**CITY OF WESTFIELD, IN**  
**Advisory Planning Commission Meeting Agenda\_05\_02\_2016**

**Monday, May 02, 2016 at 07:00 PM**

WESTFIELD-WASHINGTON TOWNSHIP  
ADVISORY PLAN COMMISSION

WESTFIELD-WASHINGTON TOWNSHIP  
ADVISORY PLAN COMMISSION

FRONT ELEVATION - MID LEVEL ENTRY - 6 Unit  
Rear Load

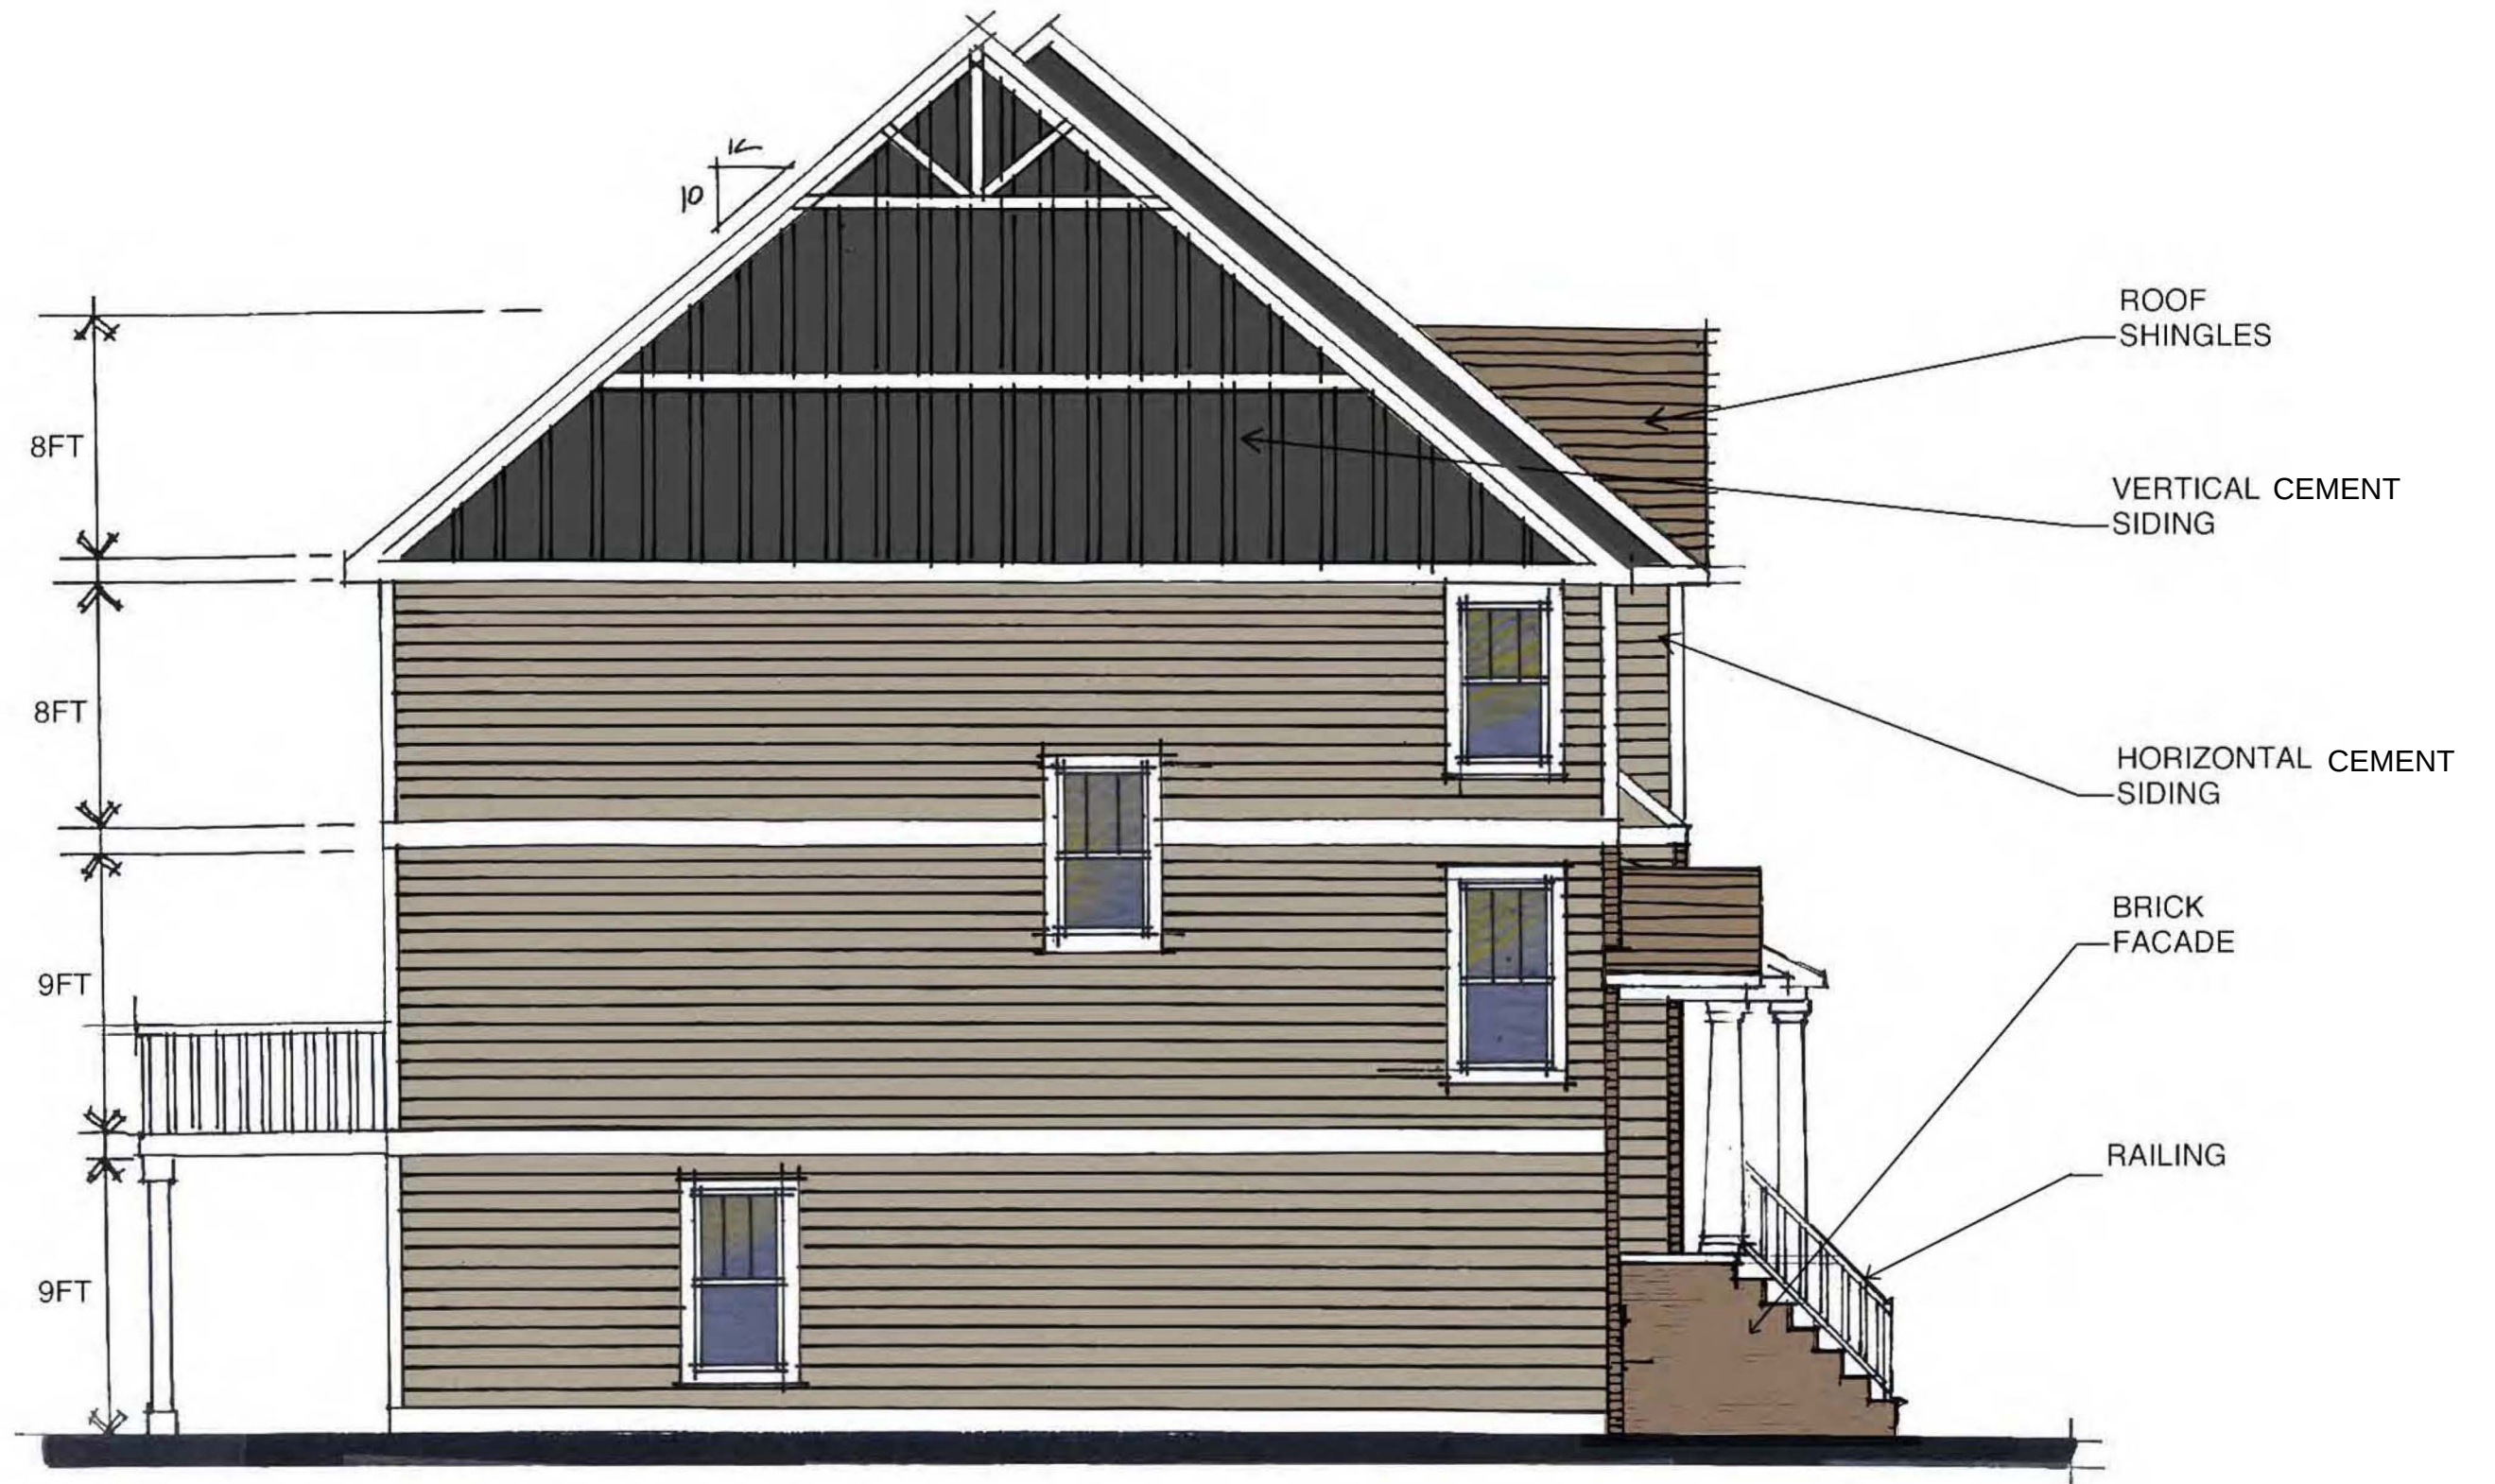
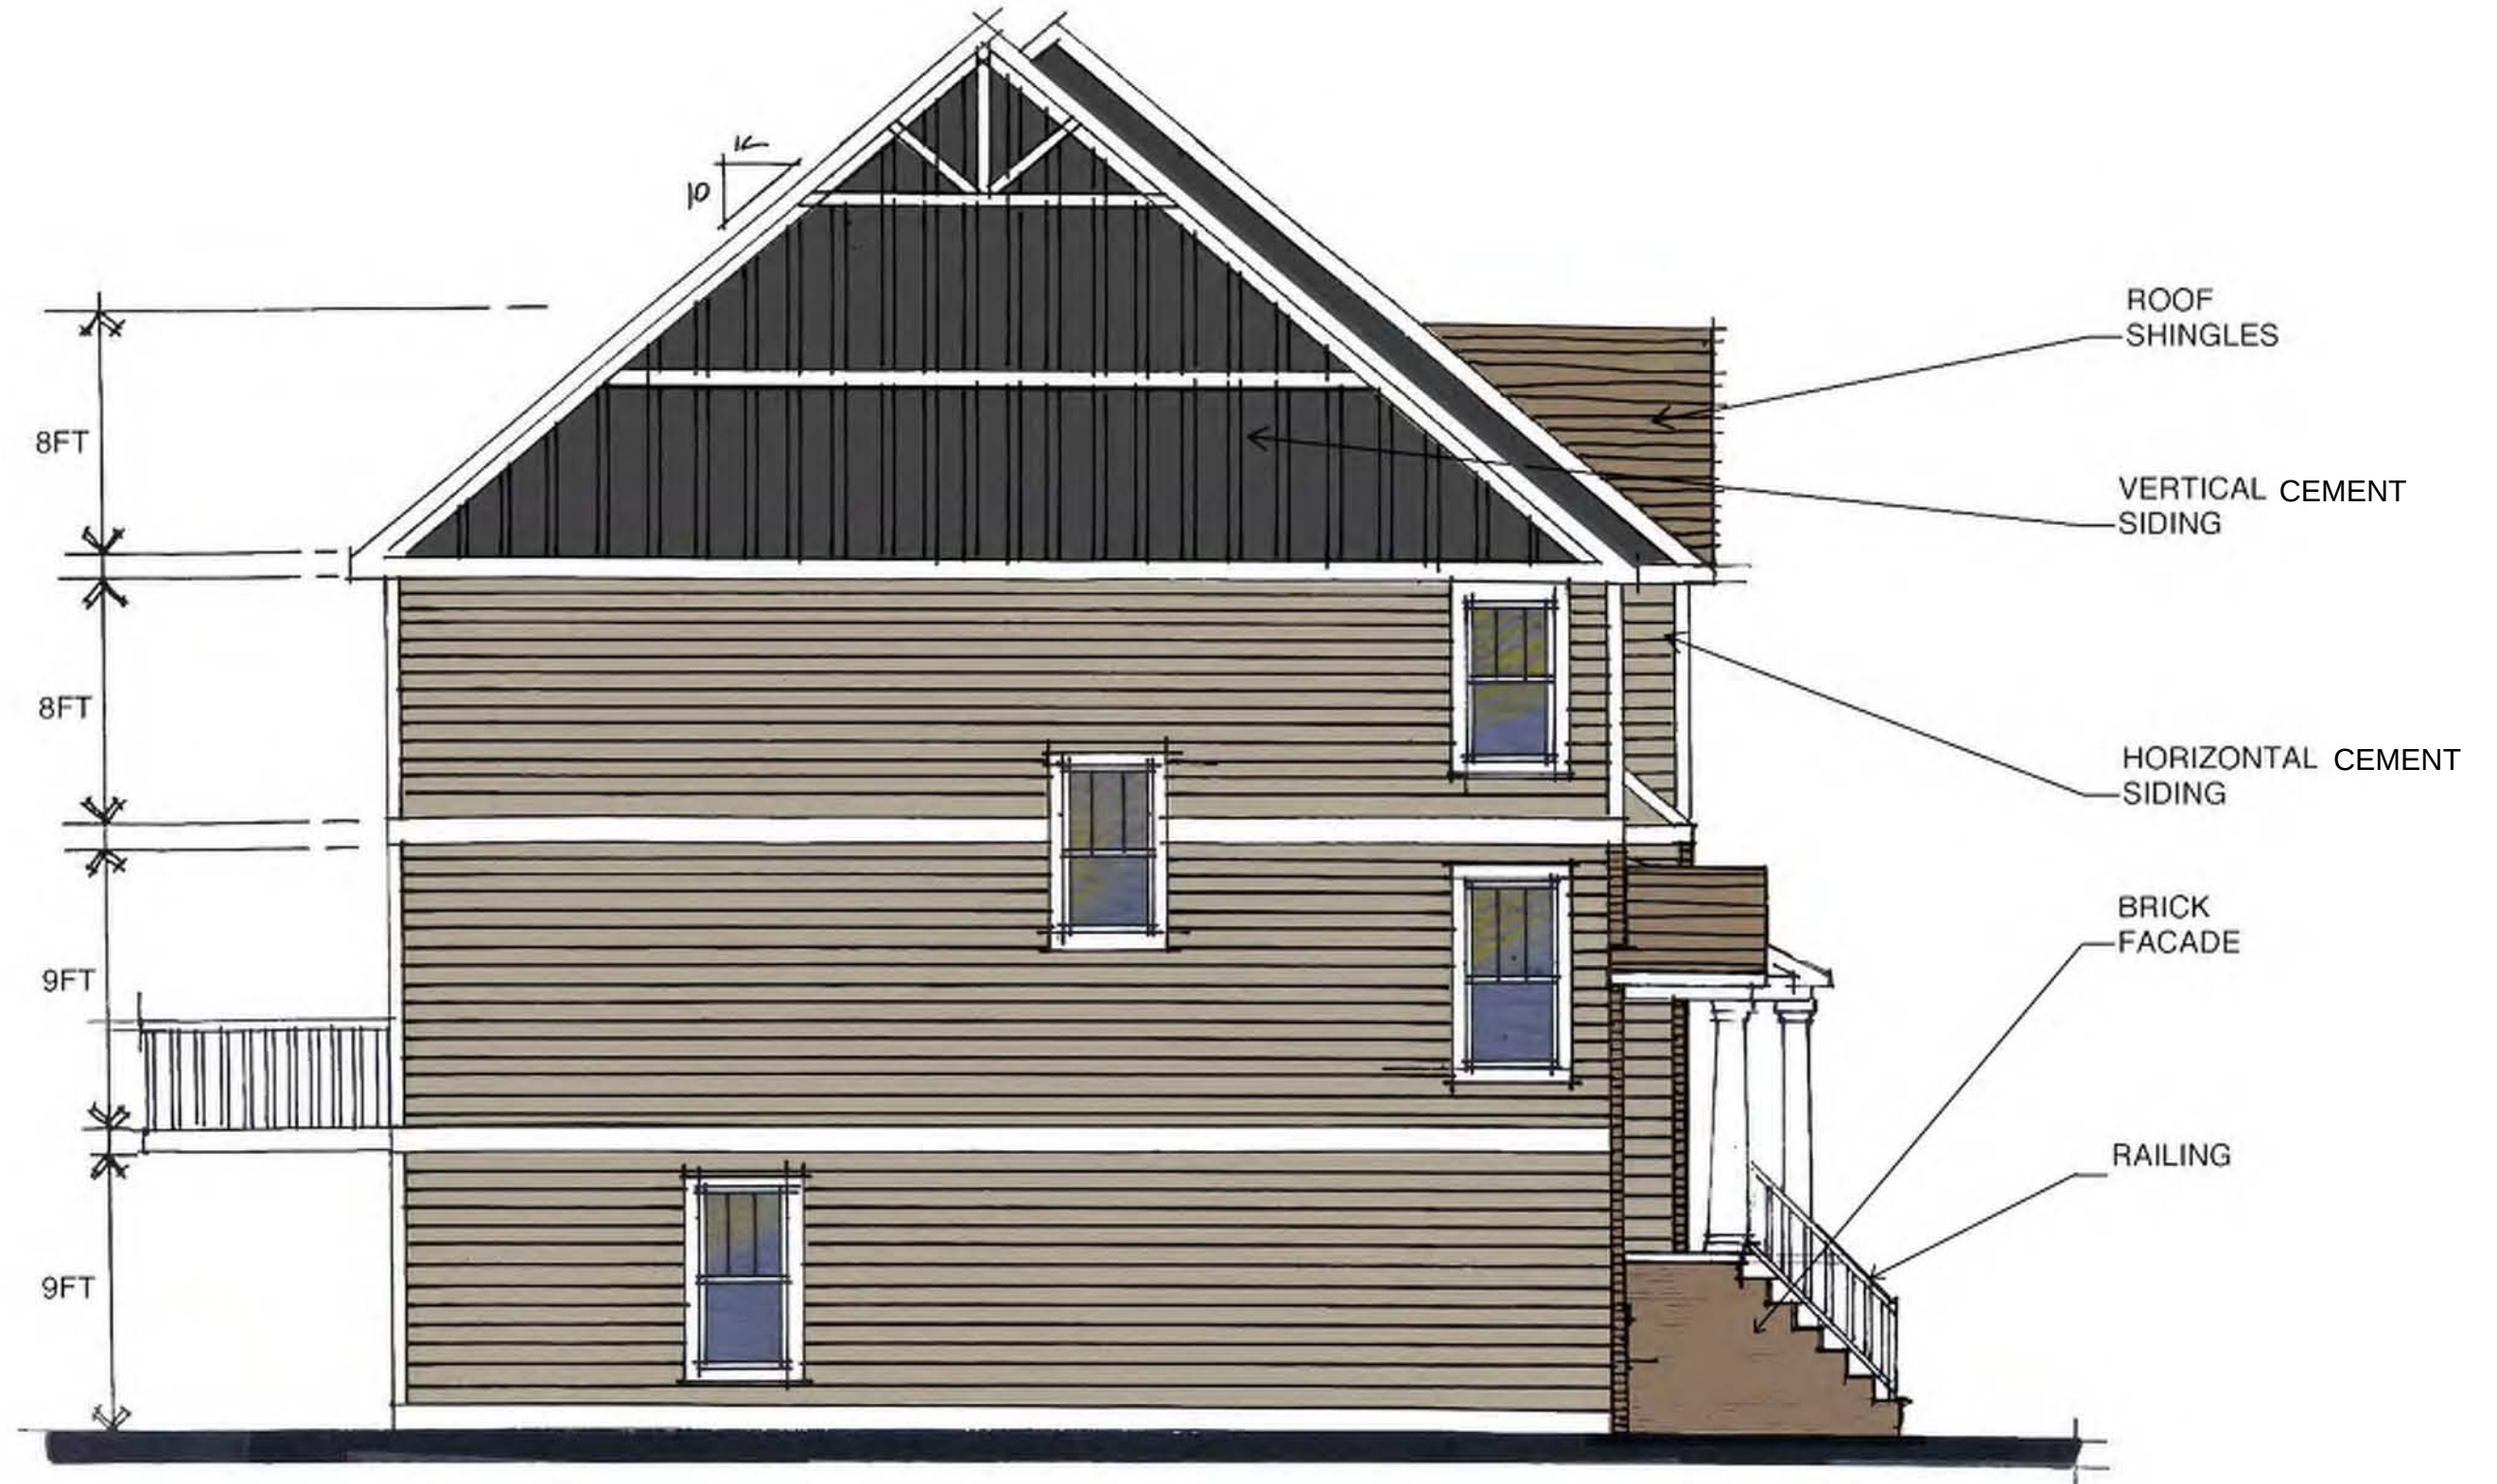
**Comment: The front elevation is applied as the building façade with the residence’s front door. As a result, the plans comply with this standard; however, please note other comments herein regarding design elements and detailing to be continued completely around each building.**

**Comment: Submitted floorplans depict the building façade offsets. Additional consideration and discussion may be warranted regarding whether the design elements and detailing from the front elevations (e.g., exterior wall materials, window treatment, roof line treatment) has been sufficiently “continued completely around each building” to comply with this standard. Due to the site design, many of the side and rear elevations are visible from the internal streets, perimeter of the site, the Monon Trail, and 161<sup>st</sup> Street.**

**Comment: Additional consideration and discussion may be warranted regarding the whether the variation to the roof form and design, particularly for those rear roofs visible from the perimeter of the site or the Monon Trail, is sufficient to comply with this standard.**
